Work Order ID 158023

Item Name: Basket Hoop

DESIGN #	DRAWN BY CP	DART AEROSPACE LTD HAWKESBURY, ONTARIO, CANADA	
CHECKED #	APPROVED #	DRAWING NO. D3166	REV. A SHEET 1 OF 1
DATE 02.07.10	TITLE BASKET HOOP		SCALE NTS
A	02.07.10	NEW ISSUE	
A1	04.04.08	38+-1 WAS 36.0

DRAWING NO. D3166	TITLE BASKET HOOP	REV A1	DART AEROSPACE LTD ENGINEERING ORDER		D.E.O. NO. D3166-A-2	SHEET NO. 1 OF 1	SCALE NTS
DRAWN AJS	CHECKED <i>[Signature]</i>	MFG. APPR. <i>[Signature]</i>	APPROVED <i>[Signature]</i>		DE APPR. <i>[Signature]</i>		
DATE 08.12.11	DATE 08.12.15	DATE 08/12/15	DATE 08/12/16		DATE 08.12.16

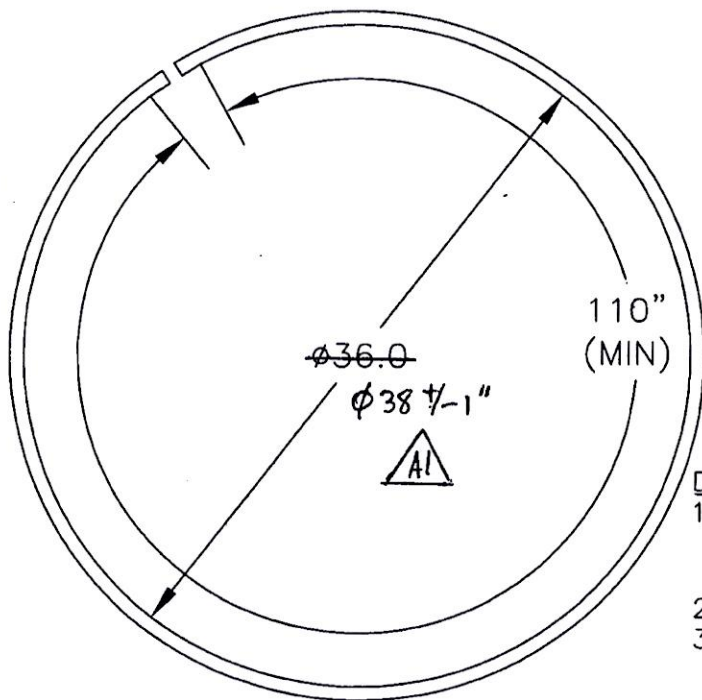
1) MODIFY MATERIAL NOTE FOR D3166-1 AS SHOWN:

WAS:

1) MATERIAL: AISI 304/316 SS SQUARE TUBING,
0.75" x 0.75" x 0.063 WALL, 60.00" LONG
(REF DART SPEC. M304TS0.750W.063)

2) MODIFY MATERIAL NOTE FOR D3166-3 AS SHOWN:

WAS:

1) MATERIAL: AISI 304/316 SS SQUARE TUBING,
0.75" x 0.75" x 0.063 WALL, 120.00" LONG
(REF DART SPEC. M304TS0.750W.063)

IS:

1) MATERIAL: AISI 304/316 SS, 3/4 X 3/4 X 0.065 WALL SQUARE TUBING,
60.00" LONG
REF. DART SPEC M304TS0.750W.065

IS:

1) MATERIAL: AISI 304/316 SS, 3/4 X 3/4 X 0.065 WALL SQUARE TUBING,
120.00" LONG
REF. DART SPEC M304TS0.750W.065
